Access Compliance Report

Public Rights-of-Way

Intersection ID: 16500	Main Street: MARSH_RD	Cross Street: SELWYN_FARMS_LN	Location: E
ADA ID: B5F6F89B5A48	Ramp Type: Directional1	Initial Pass/Fail: Fail	Overall Compliance: No
		Severity Score: 25

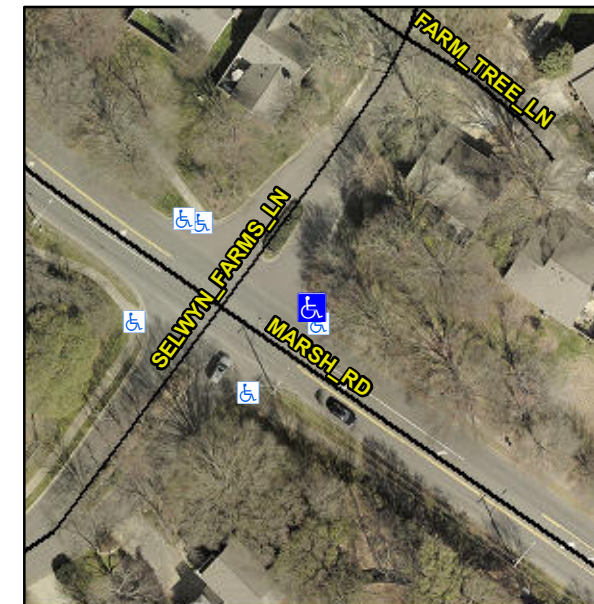
R304.5.3

Compliance	Description	Data	Compliance	Description	Data
N/A	Ramp Length (in)	41.0	N/A	Grade Break?	N/A
Yes	Ramp Width (in)	48.0	N/A	Grade Break Slope (%)	0.0
Yes	Ramp Slope (%)	5.8	N/A	Grade Break XSlope (%)	0.0
No	Ramp XSlope (%)	8.1			
N/A	Flare Type LT	N/A	N/A	Flare Type RT	N/A
N/A	Flare Slope LT (%)	N/A	N/A	Flare Slope RT (%)	0.0
N/A	Flare Traversable LT?	N/A	N/A	Flare Traversable RT?	N/A
N/A	Landing Length (in)	0.0	N/A	DWS Provided?	N/A
N/A	Landing Width (in)	0.0	N/A	DWS Contrast?	N/A
N/A	Landing Slope (%)	0.0	N/A	DWS Length (in)	N/A
N/A	Landing X Slope (%)	0.0	N/A	DWS Full Width?	N/A
N/A	Landing Curb? (Y/N)	N/A	N/A	DWS Offset LT (in)	N/A
N/A	Shared Landing?	N/A	N/A	DWS Offset RT (in)	N/A
N/A	Gutter Ponding?	0.0	N/A	Gutter Slope (%)	N/A
N/A	Gutter Lip Ht (in)	0.0	N/A	Gutter X Slope (%)	N/A
N/A	Painted X Walk1?	No		Road Slope (%)	4.3
	X Walk 1 Direction	To NW		Road X Slope (%)	1.1
	X Walk 1 Width (in)	N/A		Clear Space?	N/A

Remove & Replace Entire Ramp.
